# Access Compliance Report

### (Curb Ramps)

Intersection ID: 49925	Main Street: PAXTON_RUN_RD	Cross Street: CAMPBELL_HALL_CT	Location: NE
ADA ID: 3D4554D835FE	Ramp Type: Perp	Initial Pass/Fail: Fail	Overall Compliance: No
Severity Score: 8.75			
Codes/Mitigation Info/Possible Solution		Field Measurements/Component Compliance

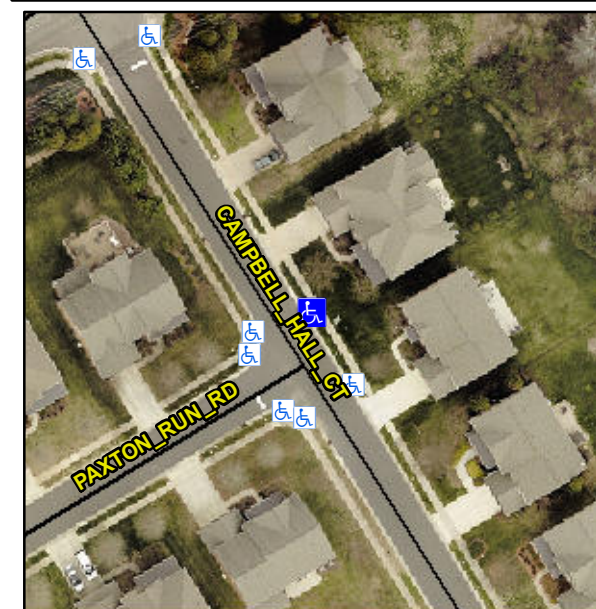
**Not Found, R304.5.1**

Compliance	Description	Data	Compliance	Description	Data
N/A	Ramp Length (in)	49.0	Yes	Ramp Slope (%)	5.0
No	Ramp Width (in)	47.0	Yes	Ramp XSlope (%)	0.7
N/A	Flare Type LT	N/A	N/A	Flare Type RT	N/A
N/A	Flare Slope LT (%)	N/A	N/A	Flare Slope RT (%)	N/A
N/A	Flare Traversable LT?	N/A	N/A	Flare Traversable RT?	N/A
N/A	Landing Length (in)	N/A	N/A	DWS Provided?	N/A
N/A	Landing Width (in)	N/A	N/A	DWS Contrast?	N/A
N/A	Landing Slope (%)	N/A	N/A	DWS Length (in)	N/A
N/A	Landing X Slope (%)	N/A	N/A	DWS Full Width?	N/A
N/A	Landing Curb? (Y/N)	N/A	N/A	DWS Offset (in)	N/A
N/A	Shared Landing?	N/A			
N/A	Gutter Ponding?	N/A	N/A	Gutter Slope (%)	N/A
N/A	Gutter Lip Ht (in)	N/A	N/A	Gutter X Slope (%)	N/A
N/A	Painted X Walk1?	No	N/A	Painted X Walk2?	N/A
	X Walk 1 Direction	To SW		X Walk 2 Direction	N/A
N/A	X Walk 1 Width (in)	N/A	N/A	X Walk 2 Width (in)	N/A
	X Walk 1 Slope (%)	3.3		X Walk 2 Slope (%)	N/A
	X Walk 1 X Slope (%)	0.7		X Walk 2 X Slope (%)	N/A

**Remove & Replace Entire Ramp.**
